**SUNDRY NOTICES AND REPORTS ON WELLS**  
**Do not use this form for proposals to drill or to re-enter an abandoned well. Use form 3160-3 (APD) for such proposals.**

On 10/21/2002, BP America Production Company submitted a request for permission to add pay in the subject well by perforating the Menefee and Lower Lewis Shale formations - EC 15335.

## Hughes C #6 Payadd Procedure

## Hughes C #6

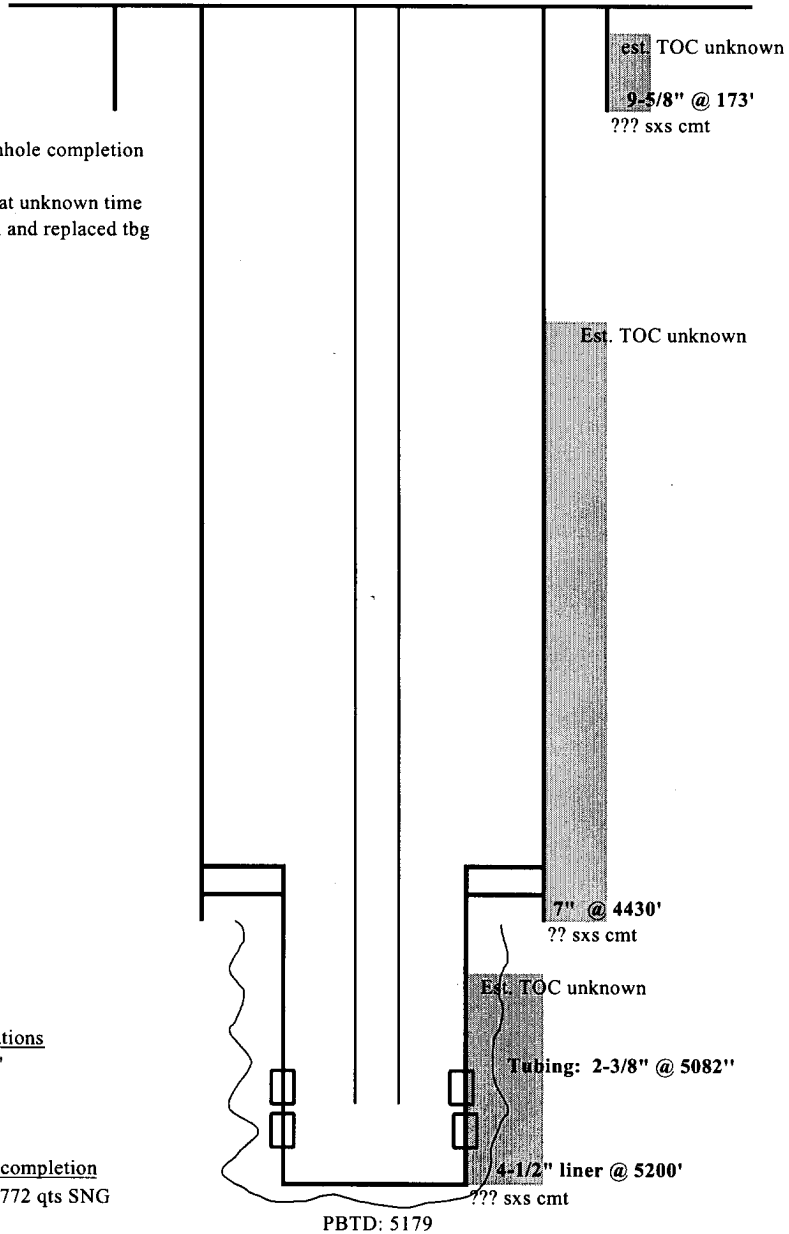
We respectfully submit for your consideration the revised procdure which indicates our intention to add pay and fracture stimulate only the Menefee formation within the subject well.
